W3F1-2004-0111

**SUBJECT:** Supplement to Amendment Request NPF-38-249,  
Extended Power Uprate  
Waterford Steam Electric Station, Unit 3  
Docket No. 50-382  
License No. NPF-38

**Revised Markup of Technical Specification Pages**

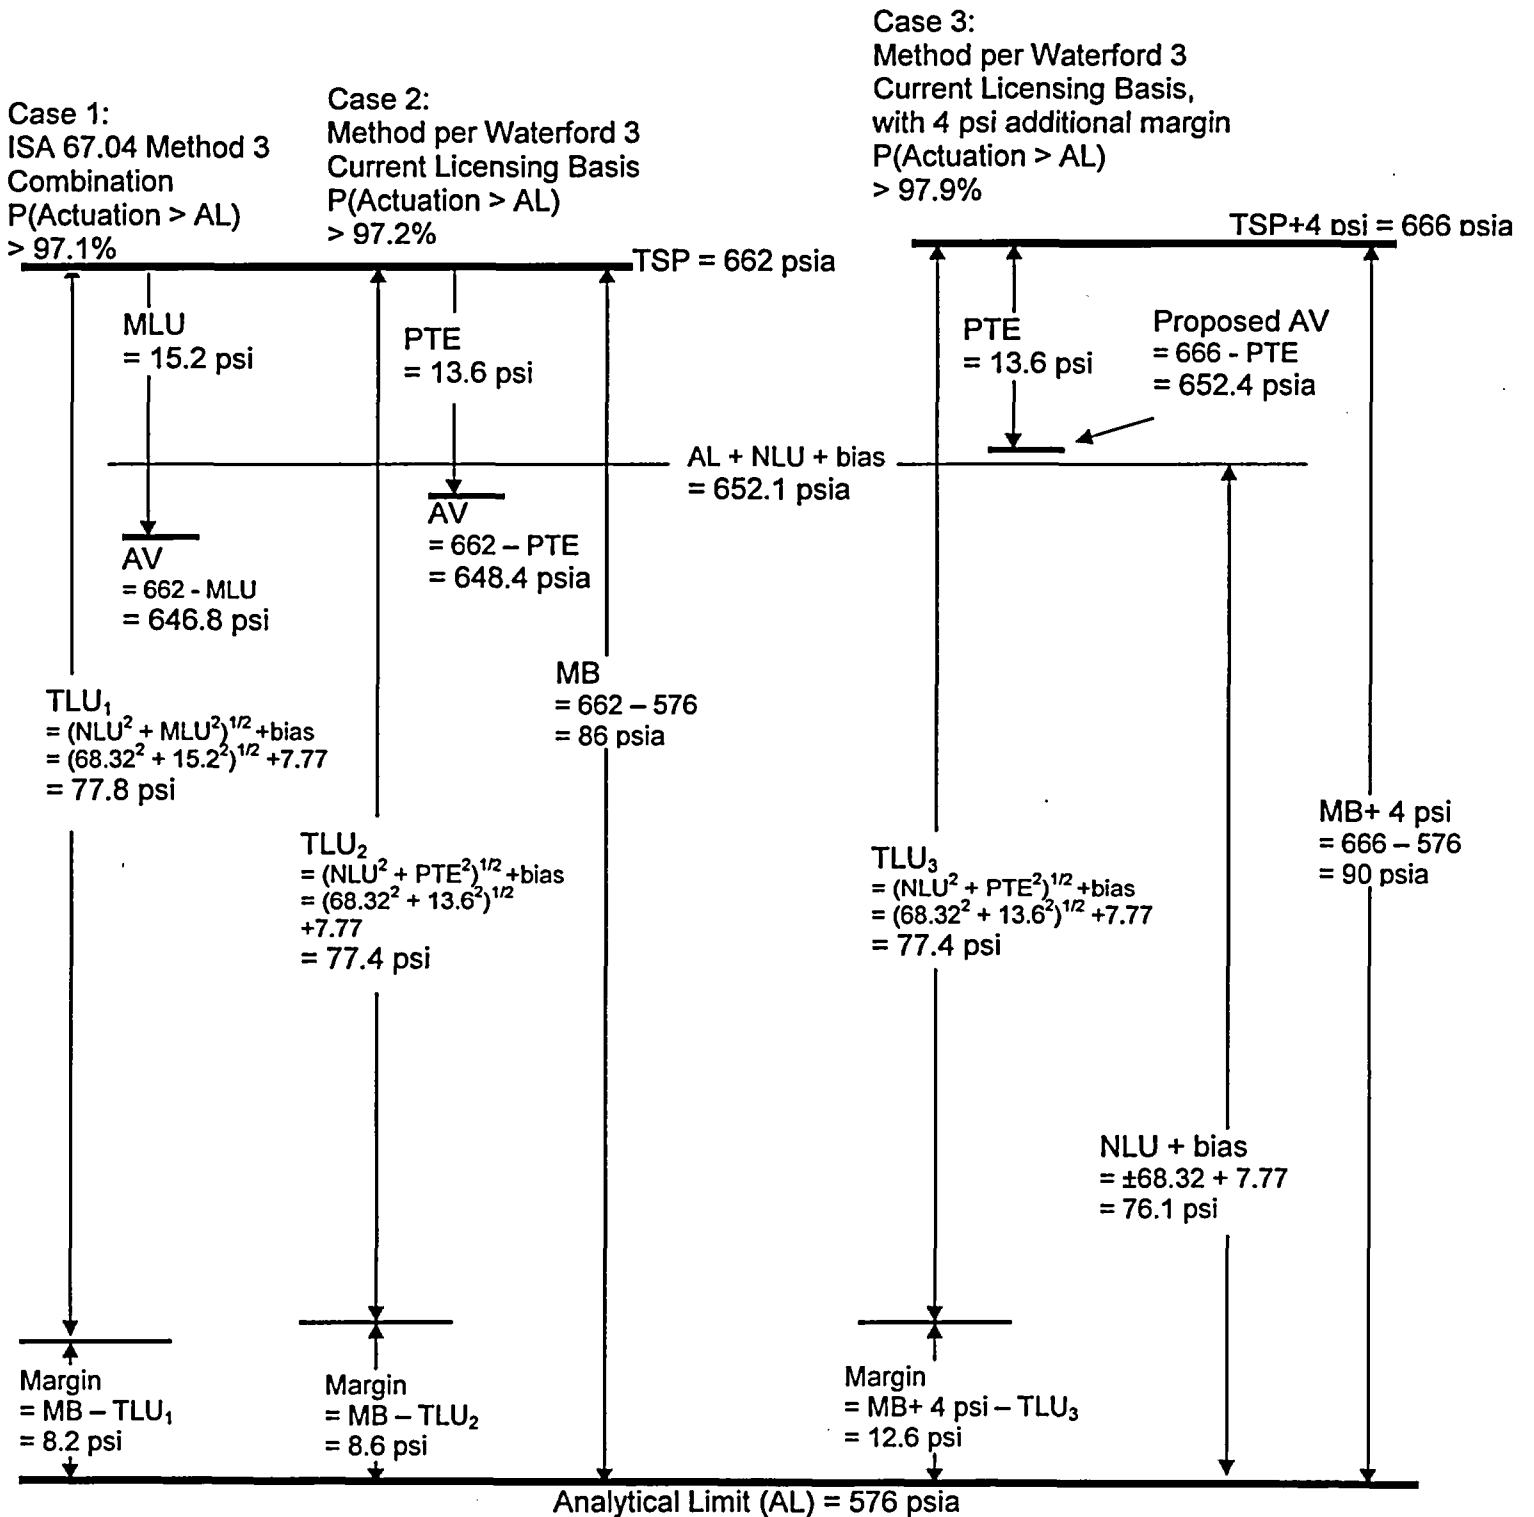
An illustration, provided below, reflects the previously proposed trip setpoint, revised setpoint, and AV as derived using three different methods:

Waterford 3 respectfully maintains its position that the trip setpoint and allowable value using Method 3 does provide adequate assurance the plant will operate in accordance with the plant safety analyses. This is demonstrated in the illustration below which includes the probability that the trip will occur at a value greater than the analytical limit for this parameter for each method. Maintaining the proposed trip setpoint as the limiting safety system setting (LSSS) derived and maintained in accordance with Waterford 3 TS assures with greater than 95/95 confidence the analytical limit will be protected. The allowable value as currently listed in Waterford 3 TS is used to determine that plant protection system trip modules perform as statistically predicted to assure the trip setpoint (i.e., LSSS) protects the AL.

The figure below illustrates the relationship between the proposed trip setpoint, new proposed setpoint, AV and AL, based on three calculation methods. NLU is the combination of the random portion of the non-measurable loop uncertainty effects. MLU is the combination of the random portion of the measurable effects, combined as they would be combined for the derivation of the TLU used to determine the trip setpoint.

Thus, the proposed trip setpoint less the PTE is greater than AL plus the non-measurable uncertainties. Entergy believes this addresses the staff's interpretation that the AV protect the analytical limit with greater than 95% probability and with 95% confidence.
